AMENDMENT OF SOLICITATION/MODIFICATION OF CONTRACT

2. AMENDMENT/MODIFICATION NO. A00004 3. EFFECTIVE DATE 08-03-2016 4. REQUISITION/PURCHASE REQ. NO. _____ 5. PROJECT NO. (if applicable) 573-13-600

Pre-Proposal RFI's - 8/3/2016

**Replace Exterior Windows E-Wing
Project 573-13-600
Malcolm Randall VAMC
Gainesville, Florida**

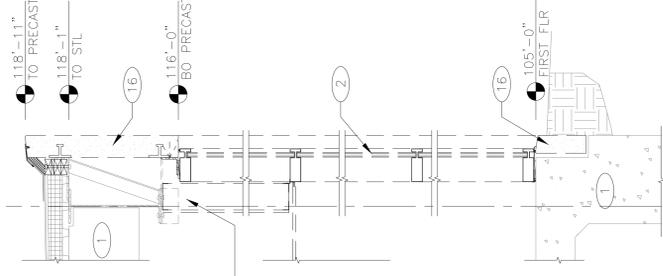
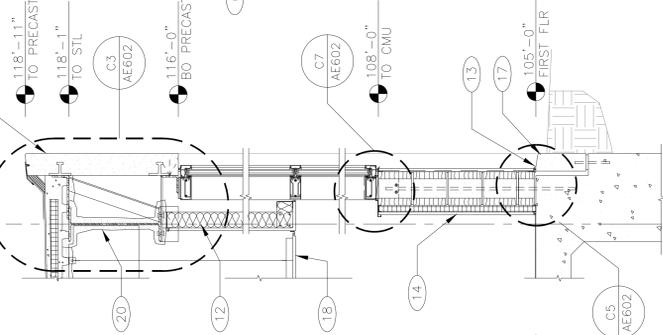
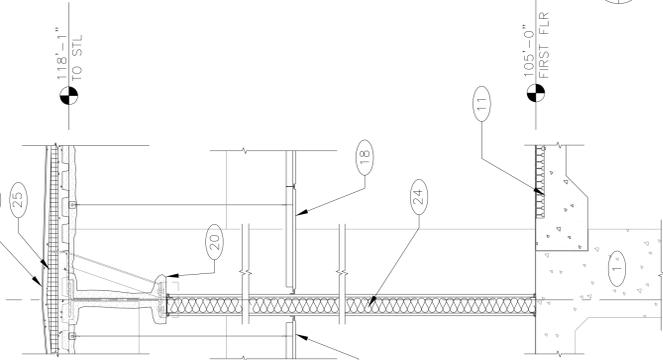
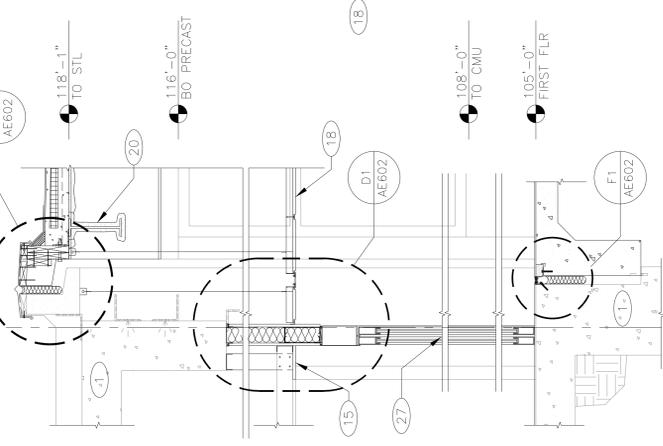
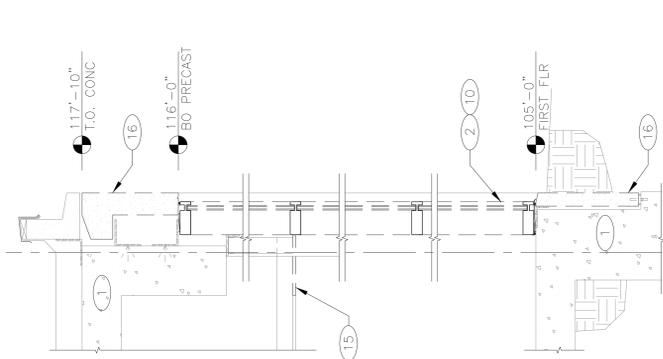
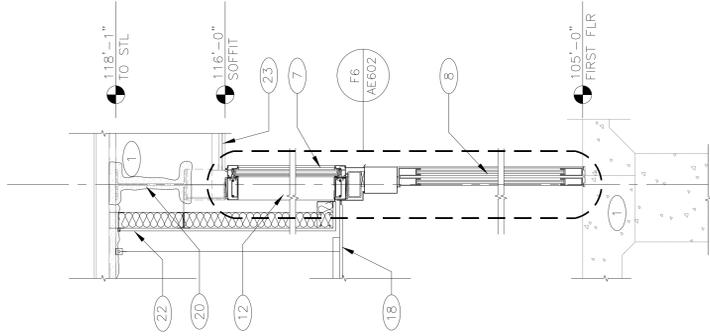
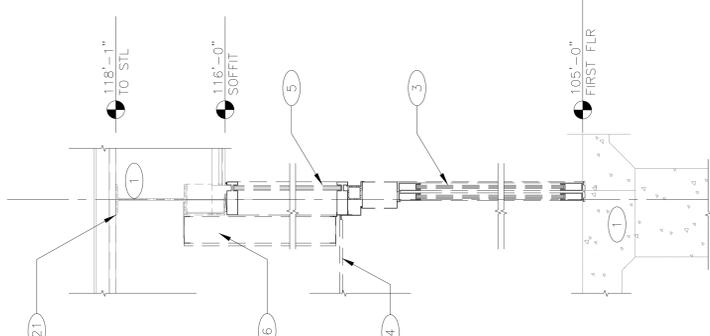
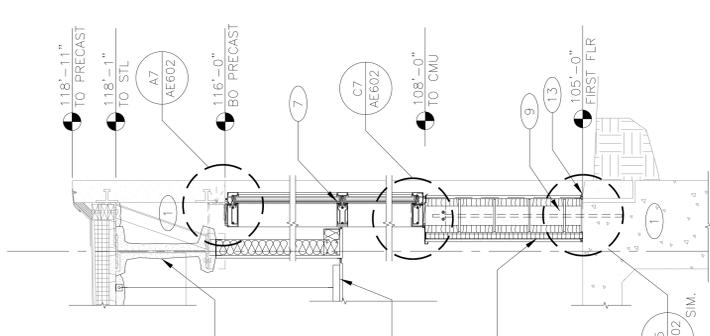
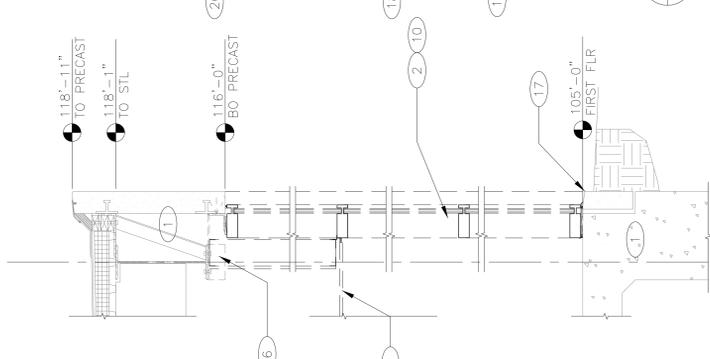
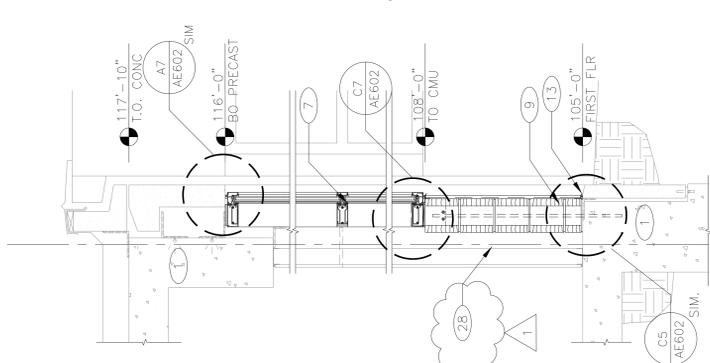
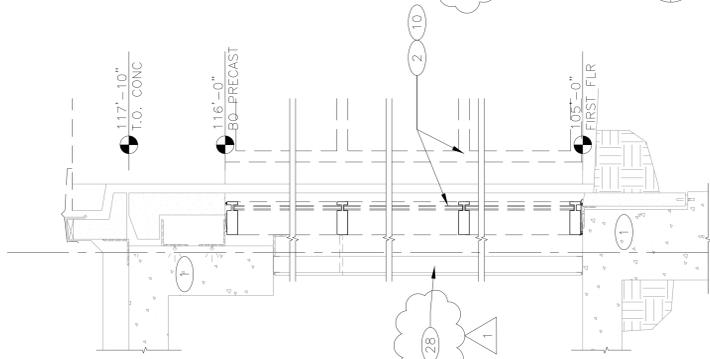
7	7. For the automatic doors on the first floor entrance, are the interior doors to be touched or is it simply the exterior façade as shown on AE205, Base bid option on Detail B3 and Alternate Bid on Detail D3?	Interior automatic doors are to be replaced in both base bid and deductive alternate. See F1 & F5 on AE401 and F1 & F6 on AE402.	A/E
8	8. Drawing AE601, details E-1, F-1, CW1-2, CW2-1, and CW4-1 do not show the Spandrel Glass over them as does CW3. The spandrel glass needs to be addressed, the required work cannot be completed without incorporating the Spandrel.	Spandrel glass is required at the curtainwall panel East of the the entrance. See CW2 on AE601 Addendum 1. Also see associated revisions per Addendum 1 on AE301, AE302 & AE401.	A/E
9			
10			
11			
12			
13			
14			
15			
16
